NUCLEAR REGULATORY COMMISSION

In the Matter of: ADVISORY COMMITTEE ON REACTOR SAFEGUARDS
SUBCOMMITTEE ON CLINCH RIVER BREEDER REACTOR
BRIEFING ON CLINCH RIVER BREEDER REACTOR
GEOLOGY AND SEISMOLOGY

DATE: June 1, 1982 PAGES: 1 - 290
AT: Washington, D. C.

FIGURE 13

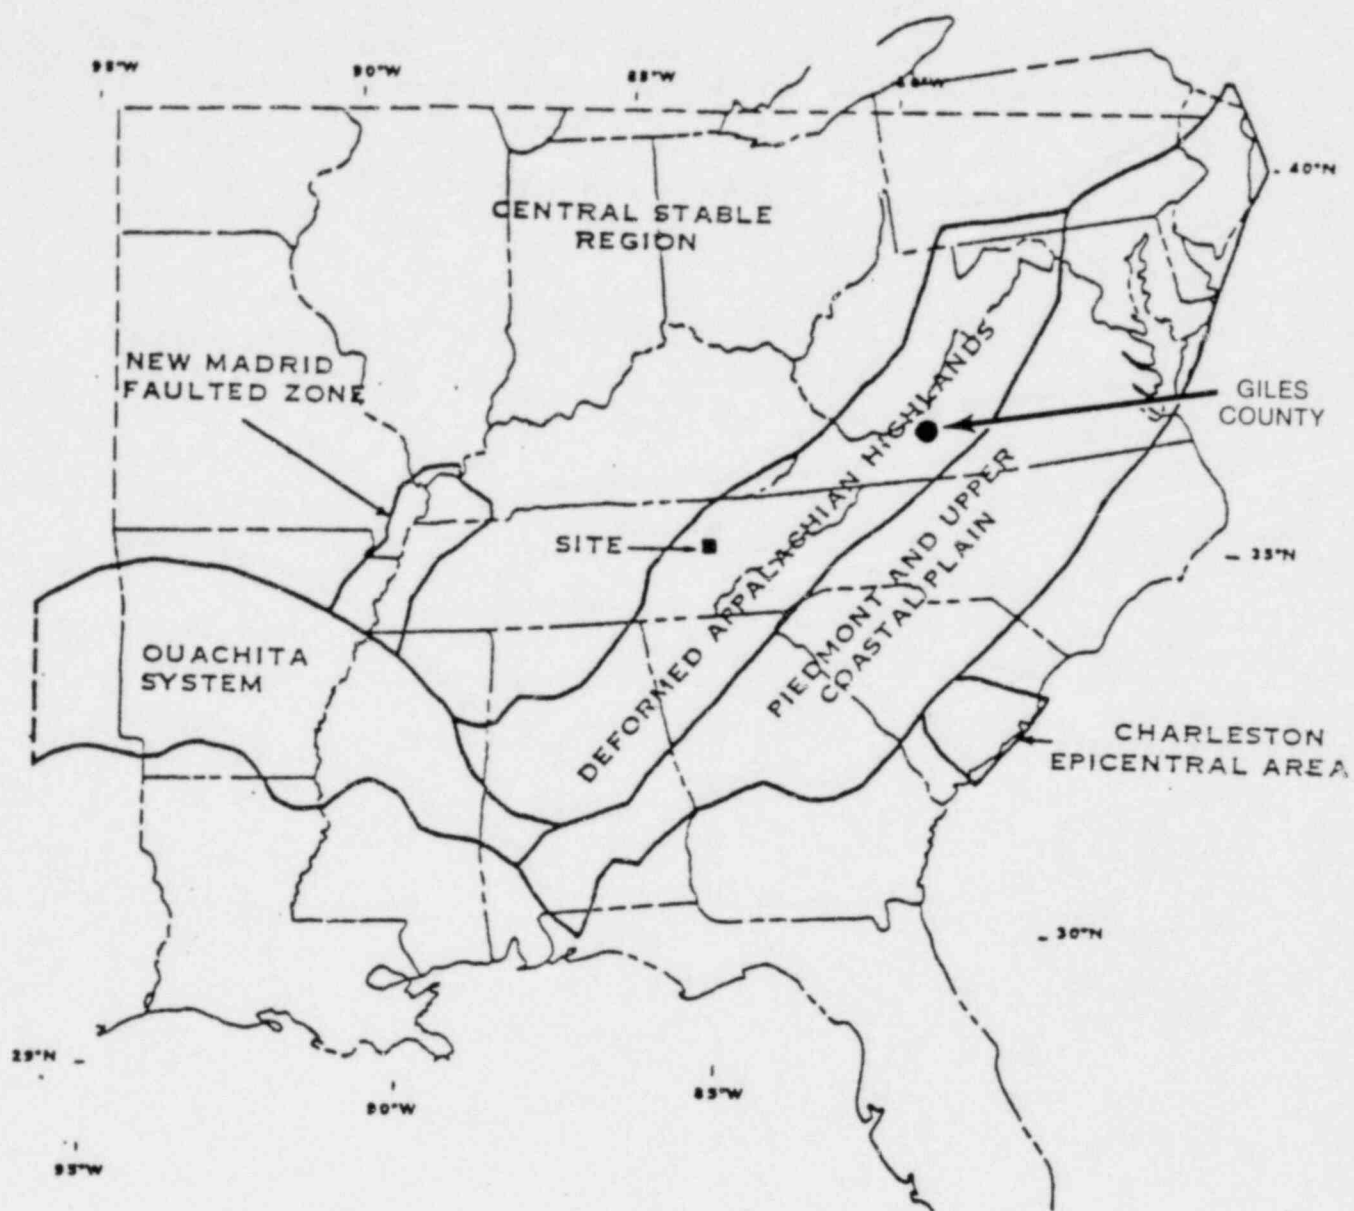
11 MR. TRIFUNAC: Could I ask a question
12 regarding the preceding vu-graph that had a 50-mile
13 radius?

14 MR. TRIFUNAC: Could I ask one more question,
15 please? Could you put on the viewgraph, I believe,
16 number 13? It is the one that has regional earthquakes
17 with intensity exceeded for MMI. It has a 50-mile
18 radius and a 200-mile radius.
